KC750 TO KW11-K

DECOLOG Engineering Change Order Log

FIELD CHANGE ORDER

FCO KC750 P 0001 PAGE 1 of 13

Figure 4

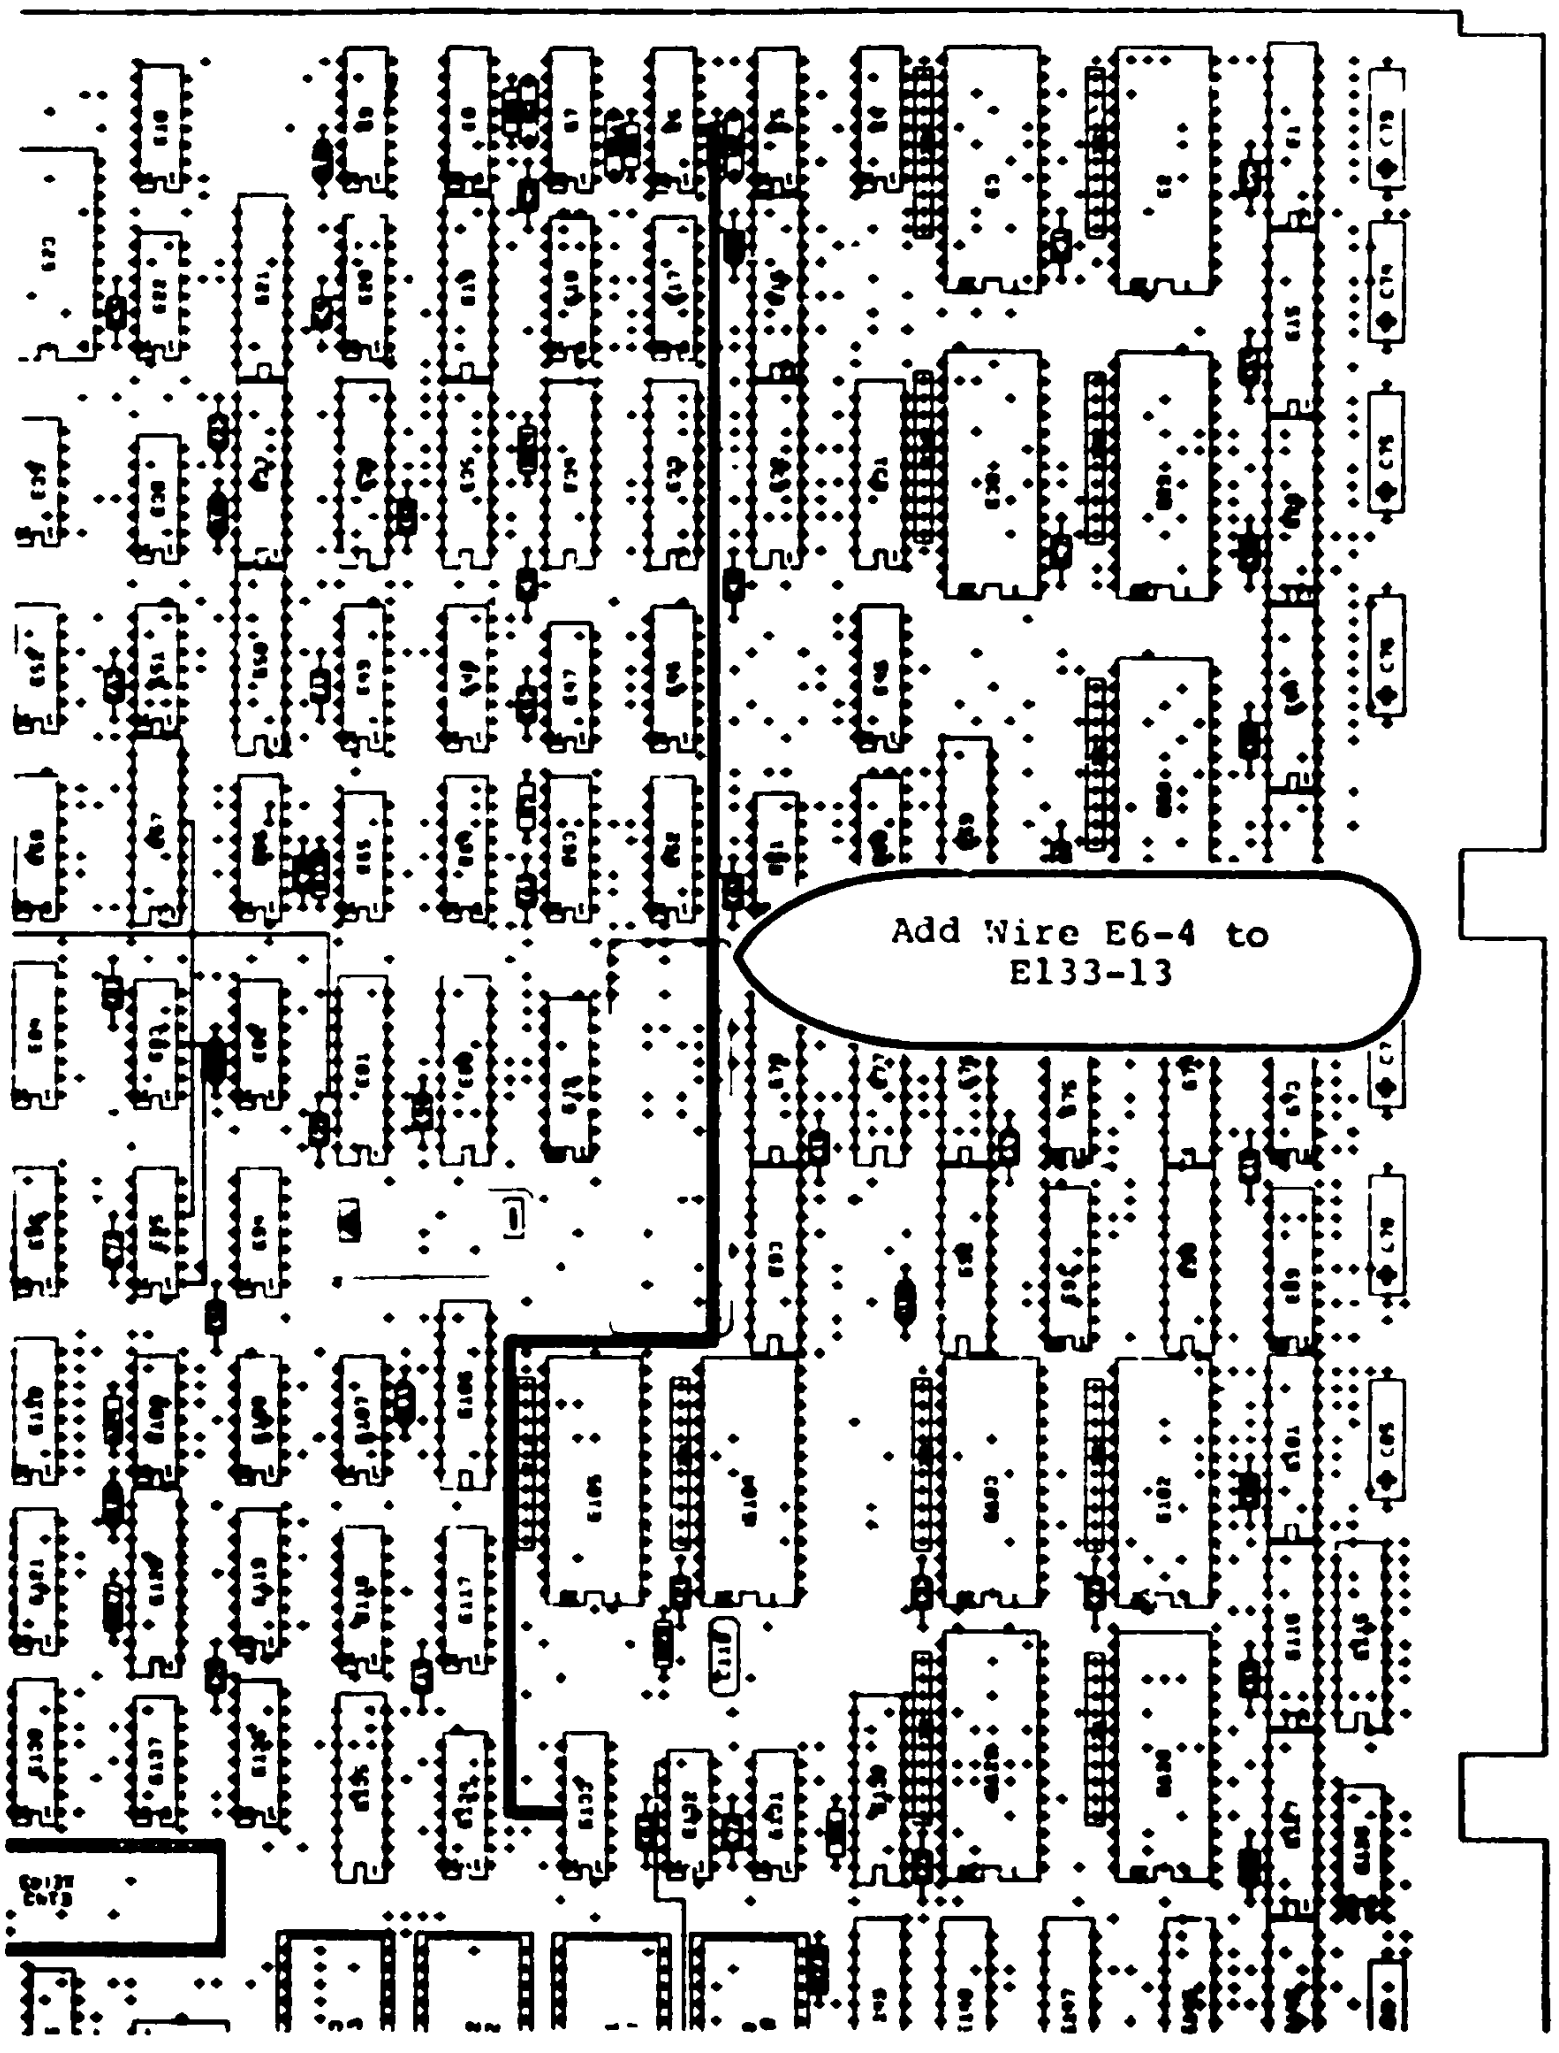
FROM	TO	FIGURE
E12 pin 12	E42 pin 13	figure 3
E6 pin 3	E12 pin 13	figure 3
E6 pin 4	E133 pin 13	figure 4
E133 pin 15	E134 pin 8	figure 5
E133 pin 14	E176 pin 24	figure 6
E133 pin 12	E187 pin 5	figure 6

FIGURE 1

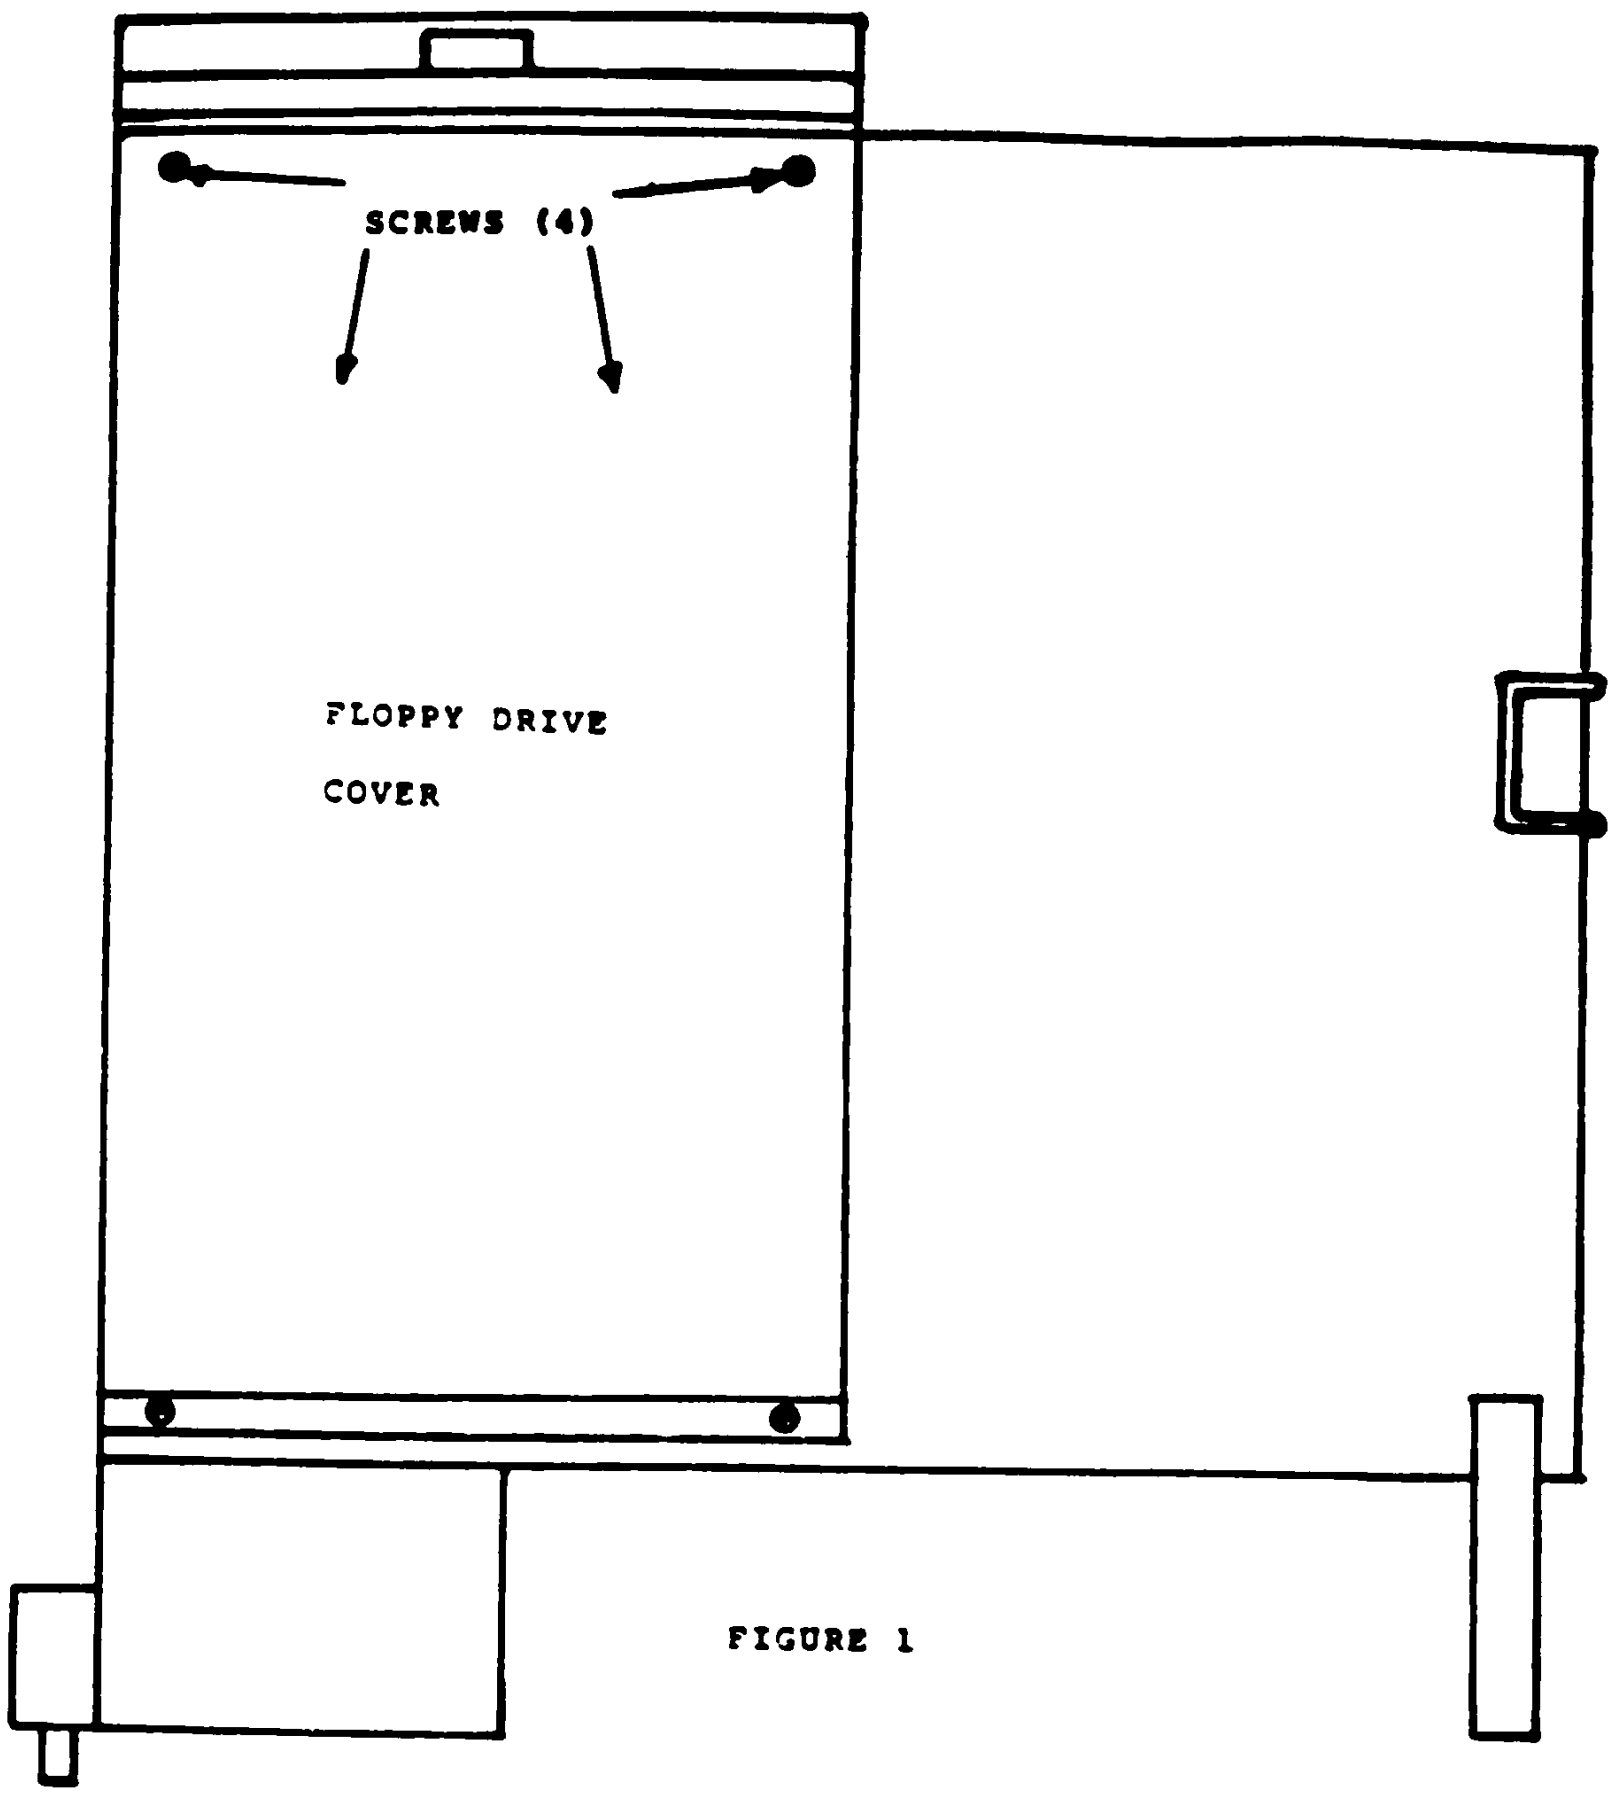
4. Remove cover from floppy drive (figure 1). The cover is held in place by four screws.

Figure 2

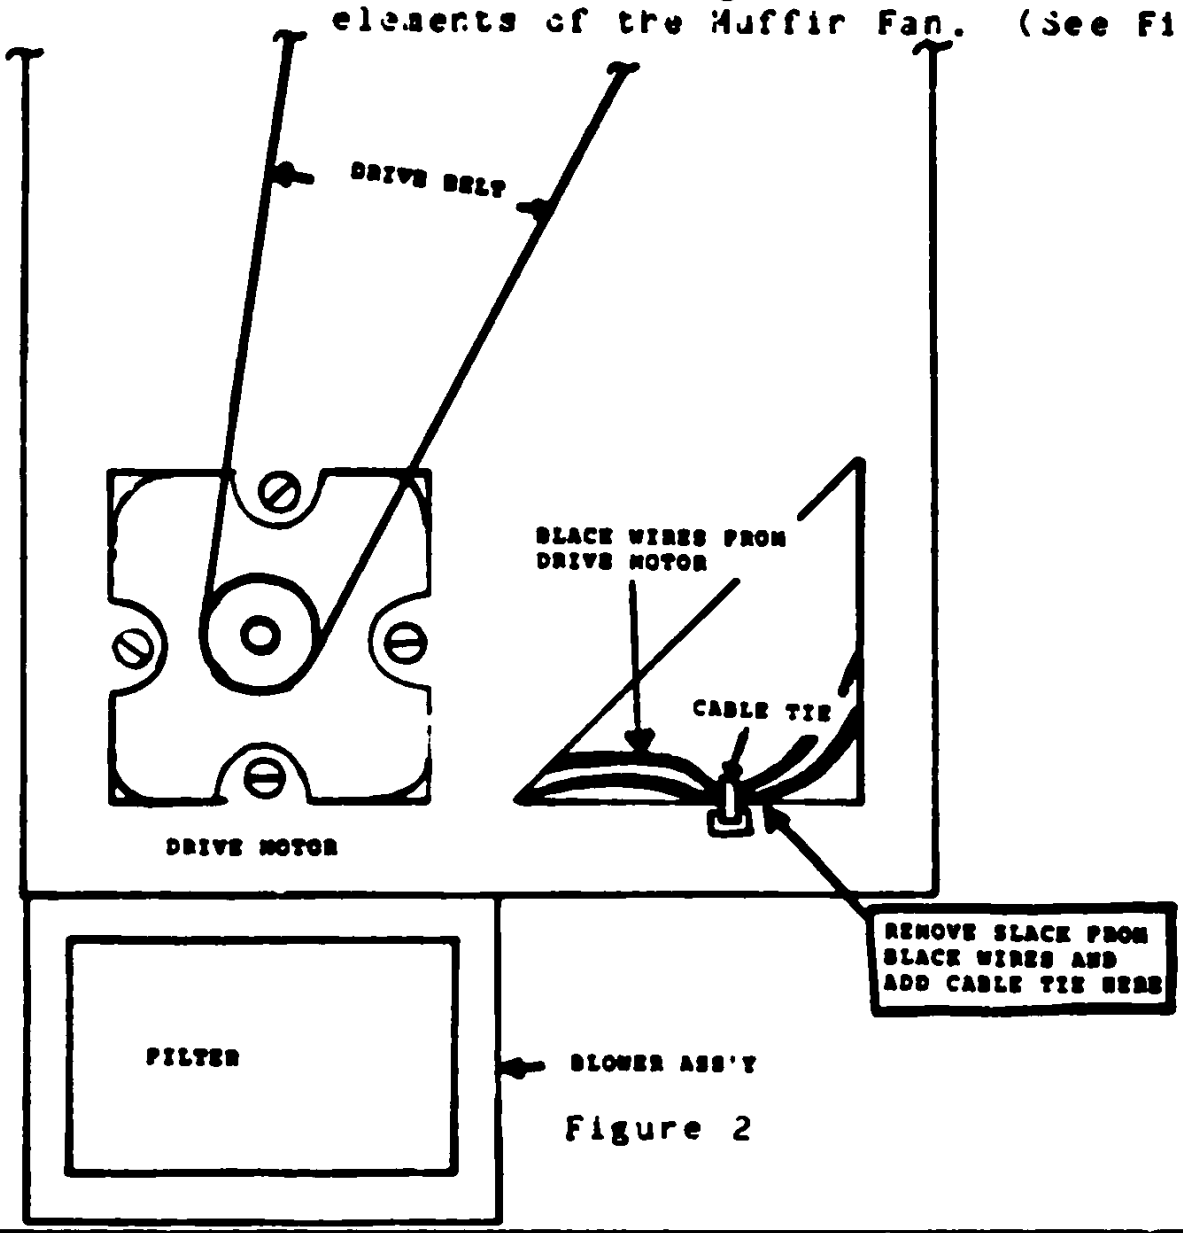
6.2 Install an additional cable tie to the right of and as close as possible to the cable tie (installed in the chassis). This will prevent wires from coming into contact with the moving elements of the Muffin Fan. (See Figure 2).

Figure 1

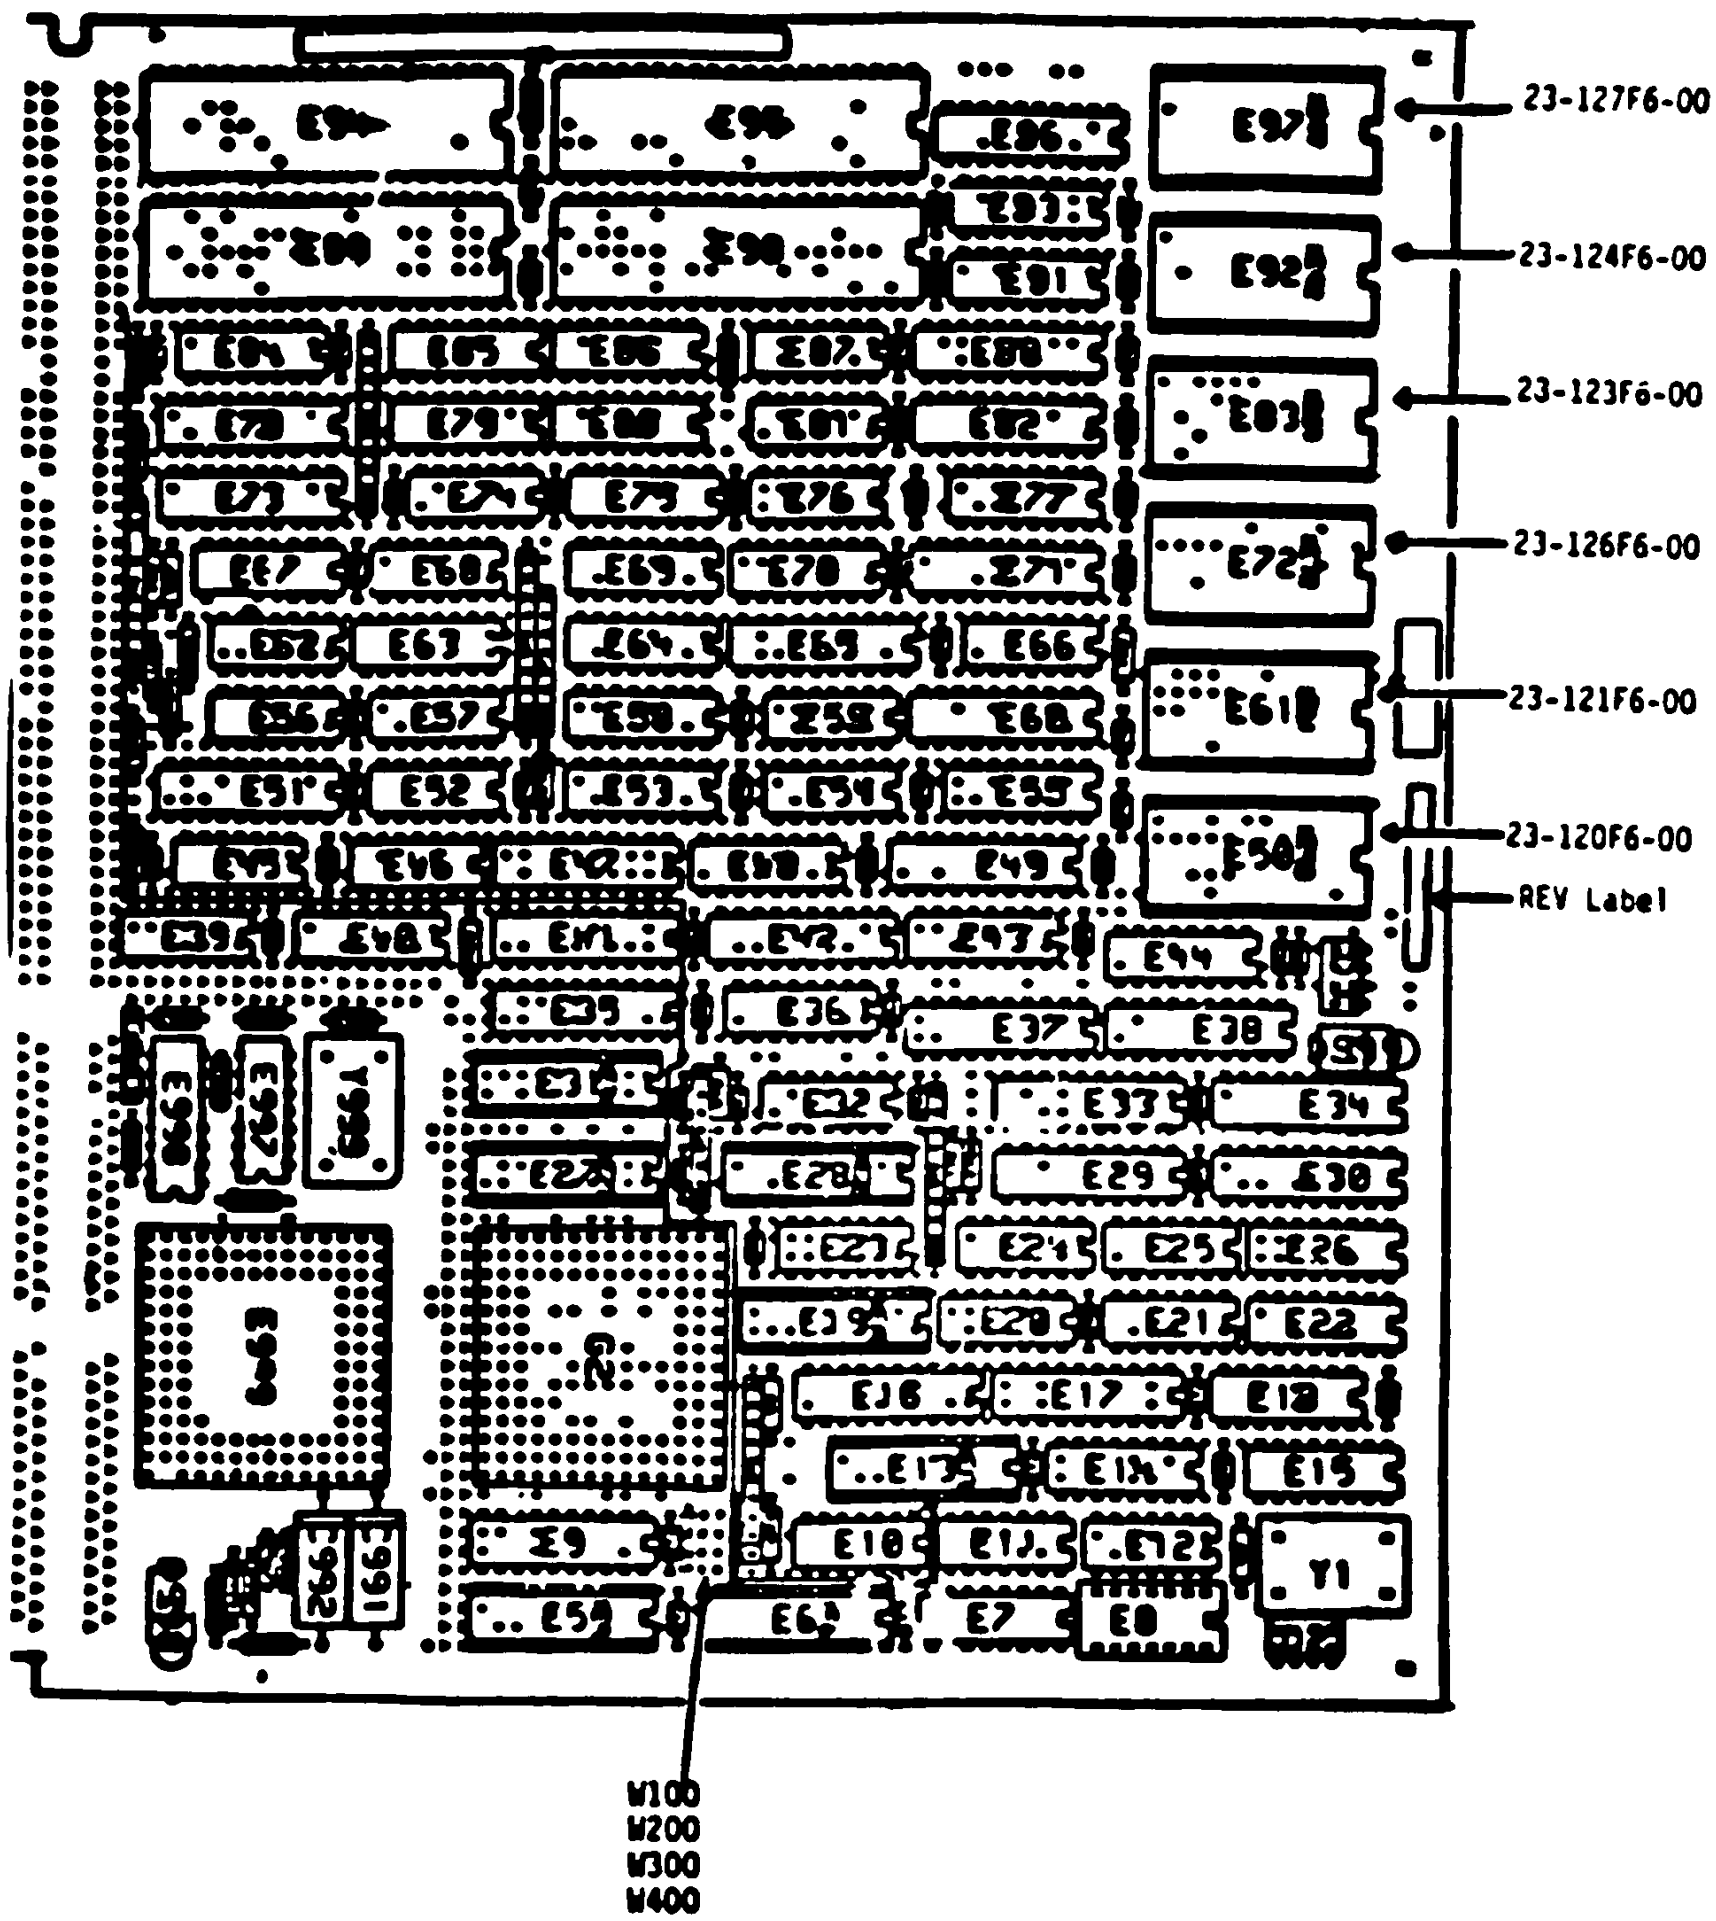
7. Locate the six PROM sockets in the upper left hand portion of the module (FIGURE 1).

10. Locate the jumpers W100,W200,W300,W400 on the right hand side of the module (FIGURE 1). Set the jumpers according to the chart (FIGURE 2).
